REGULAR MEETING OF THE PLANNING COMMISSION

Monday, July 06, 2026

A. West Villages Residences – 315 N Lapeer Street

**Subject: VLO-25-03 West Village (315 N Lapeer Road), Final Site Plan Review
Planning Commission Reconsideration**

Plan View Rendered

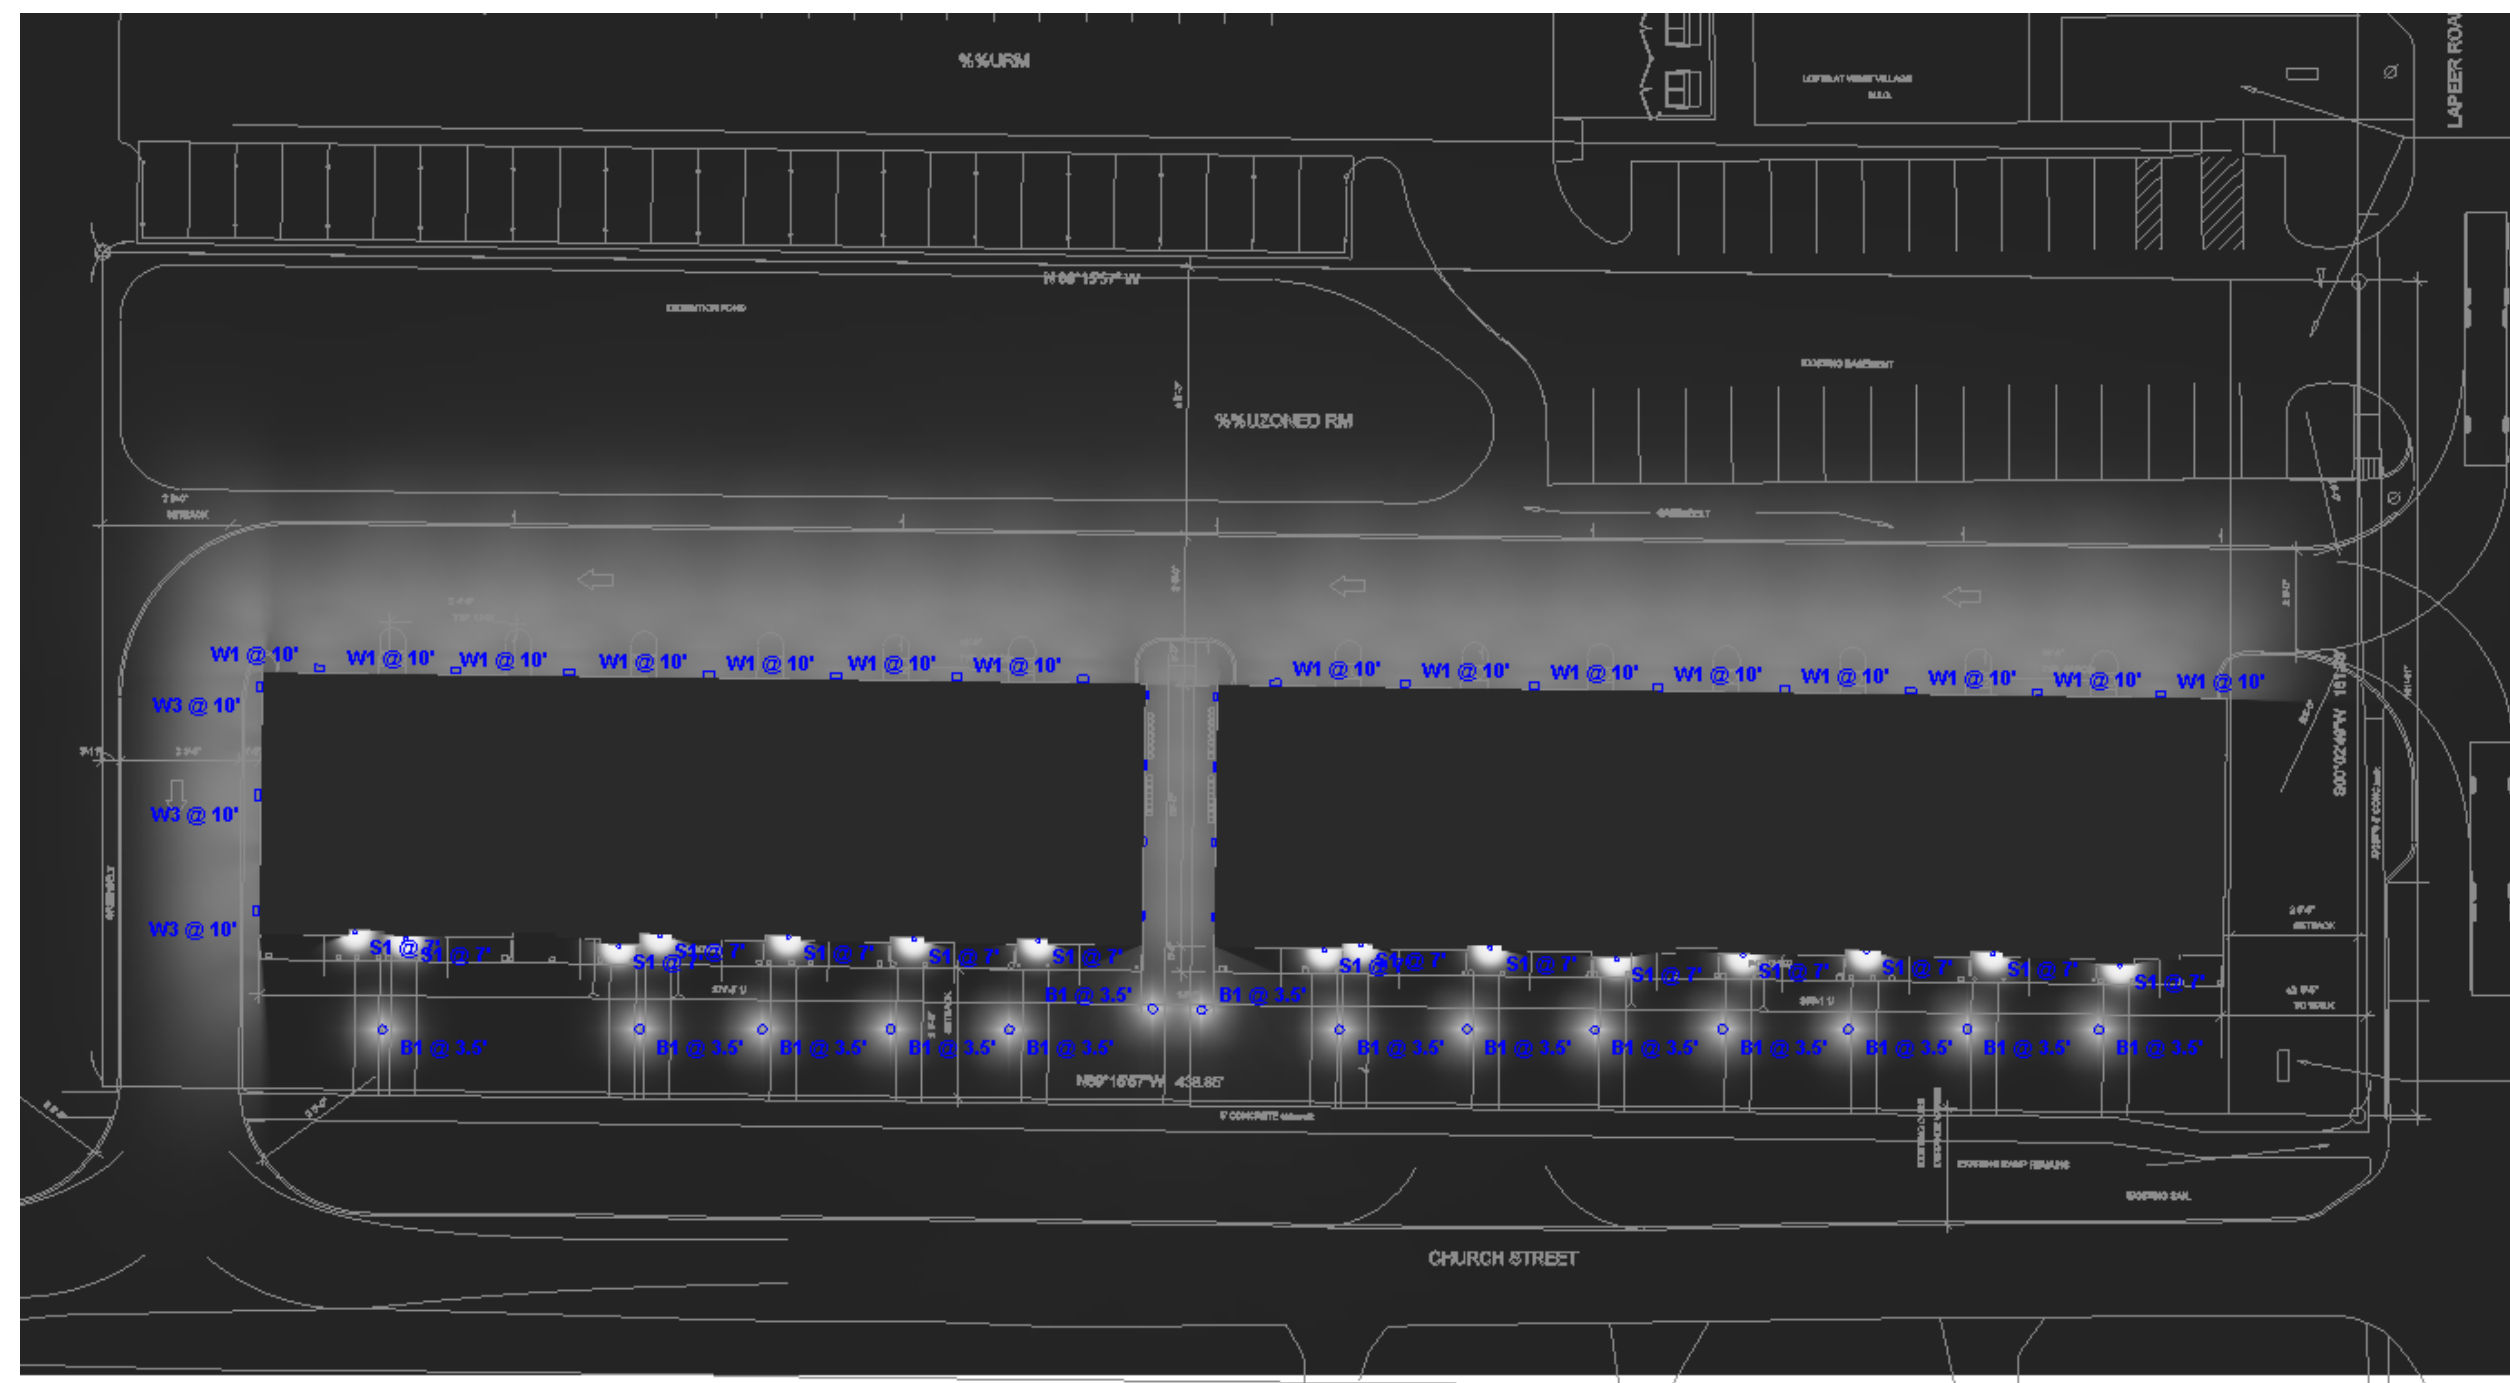
- Addressing the simplest conditional requirement first, we note that the submitted photometric plan indicates a certain amount of light bleeding across the west property line. Light sources must be designed to not impact adjacent properties.
 1. A related issue is noted in our first site plan review, where the existing on-site tree buffer along the property line is being removed, and no replacement screening has been proposed between this site and the dissimilar land use to the west, as required by Zoning Ordinance.

- Acknowledged & updated plan with items shown. Photometrics plans updated.
